PROJECT: Summerlin West V22-Lake Mead Blvd. Street Improvements

SUBMITTAL: 2nd

CITY OF LAS VEGAS INTER-OFFICE MEMORANDUM				DATE: September 30, 2019
TO: **Land Development Services** Department of Building & Safety				FROM: Albert Sung, P.E. Flood Control Project Engineer Department of Public Works
SUBJECT:	Drainage Study for: **Summerlin West V22 – Lake Mead Blvd. Street Improvements from Desert Foothill Boulevard to Kettle Ridge Drive (Street J) (also Lake Mead Rough Grade from Kettle Ridge to Scurry Bend)**			**COPIES TO:** Atkins
Cross Streets:	Lake Mead Boulevard & Desert Foothill Drive			Howard Hughes Company, LLC
File Number:	F:\Depot\DSMemos\DS5155B.doc			Bart Anderson, P.E., DevCo
Parcel Number:	137-14-401-006 & 137-23-101-002			CCRFCD
Zoning Action:	N/A			
FEMA Flood Zone	YES	NO	**X**	
Proposed Storm Drain	YES	NO	**X**

The Drainage Study for the subject project has been reviewed and:

X:\Projects\SummWest\Village 22\100060653 - V22N Lake Mead (Desert Foothills to Street N)_Sheets\60653-09-PLAN-P1.dwg LAYOUT: 19 Sep 11, 2019 - 8:40AM

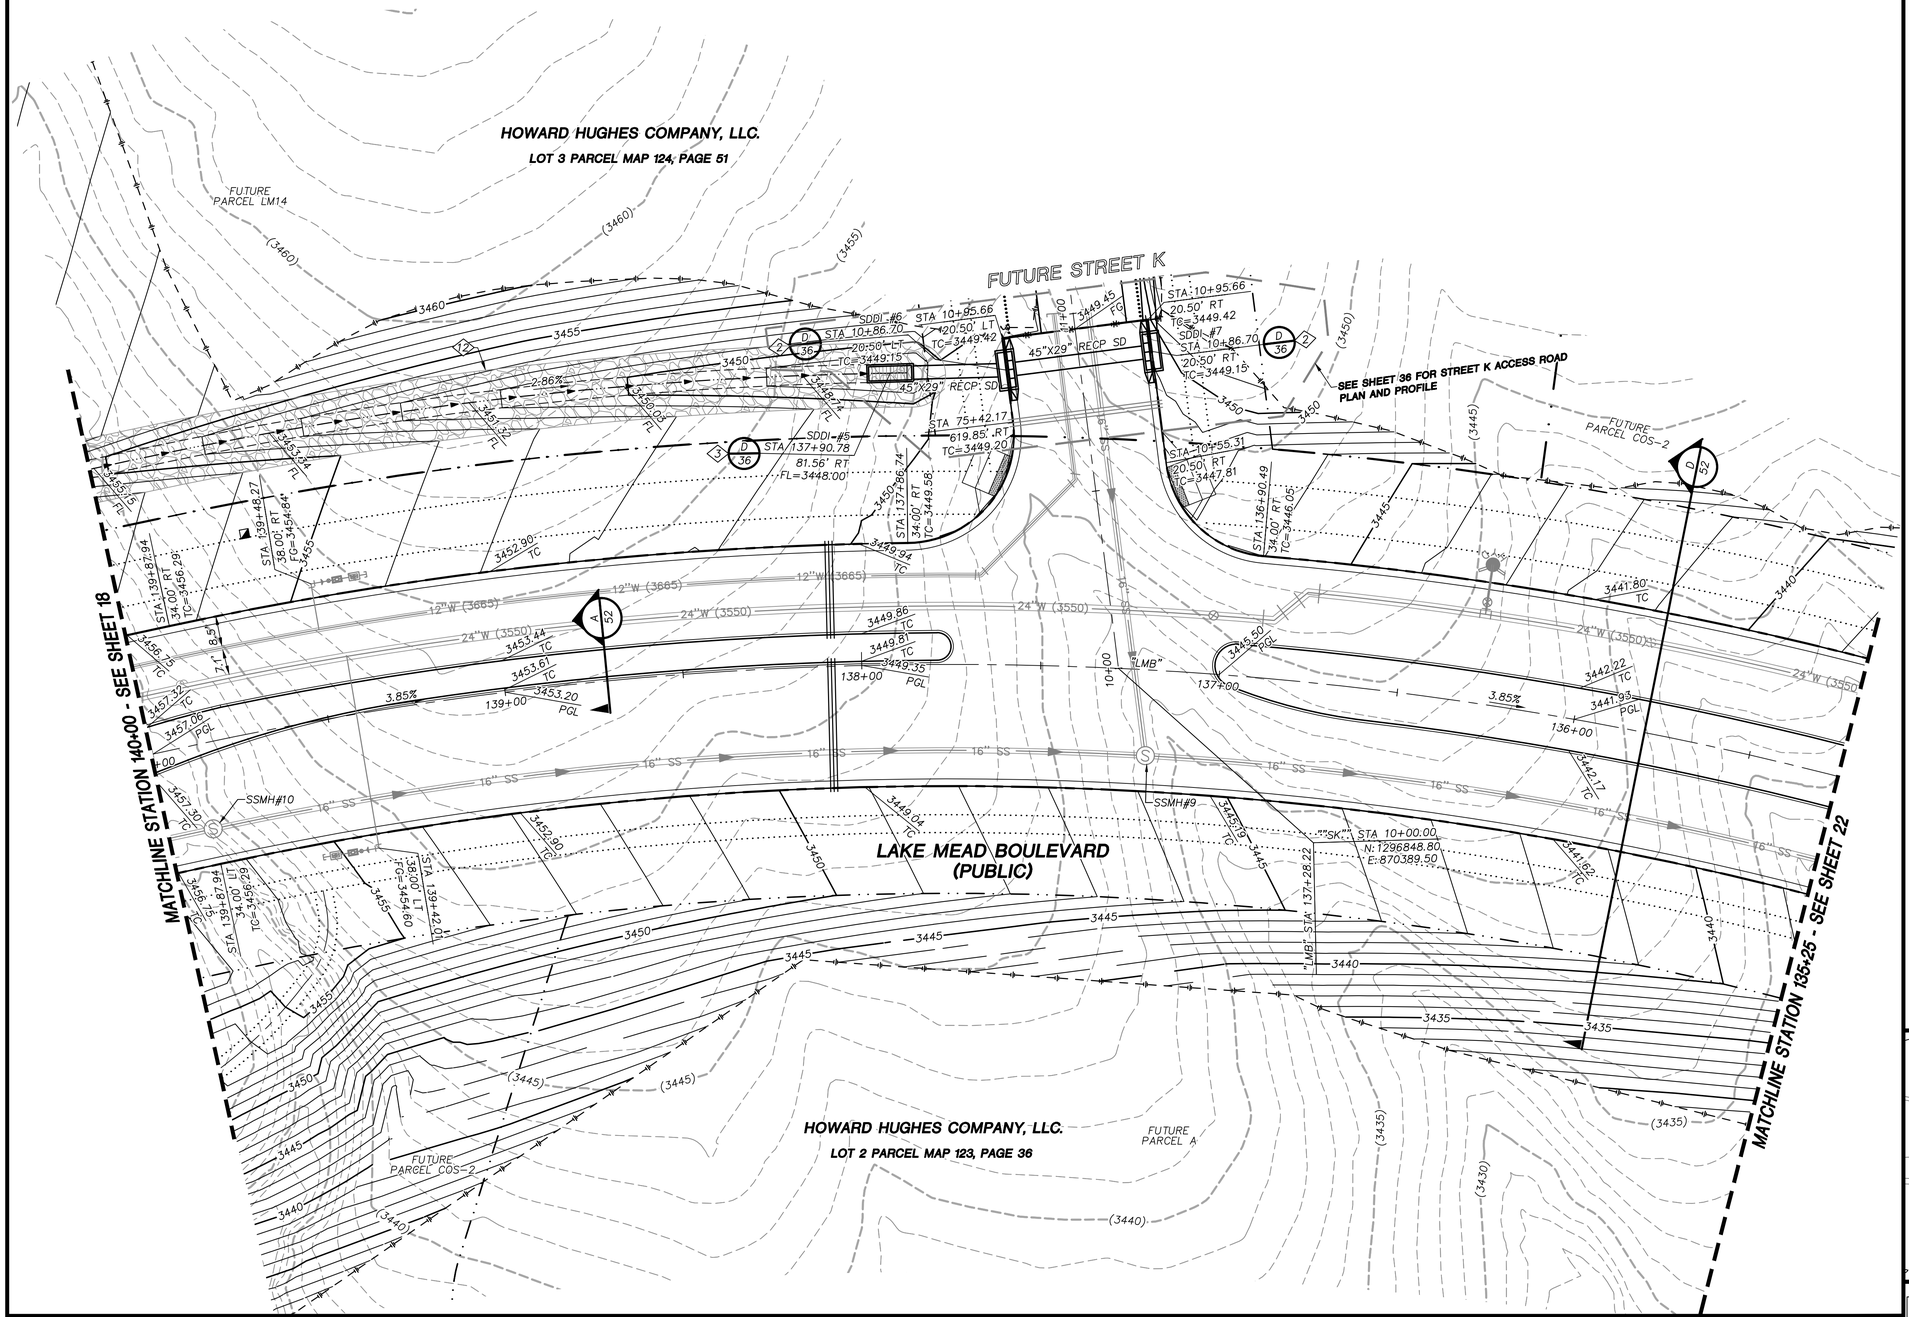
4. ***Sheet 18/66:*** Previous comment required finished grade elevation to be labeled at the entrance of the pedestrian tunnel. It is understood that the pedestrian tunnel may function as an emergency overflow path. However, based on the revised grading design, the pedestrian tunnel will function as a regular drainage path because the entrance is lower than the two inlets. Raise the entrance of the tunnel to at least 18" above the finished grade of SDDI #11. Review and revise accordingly.
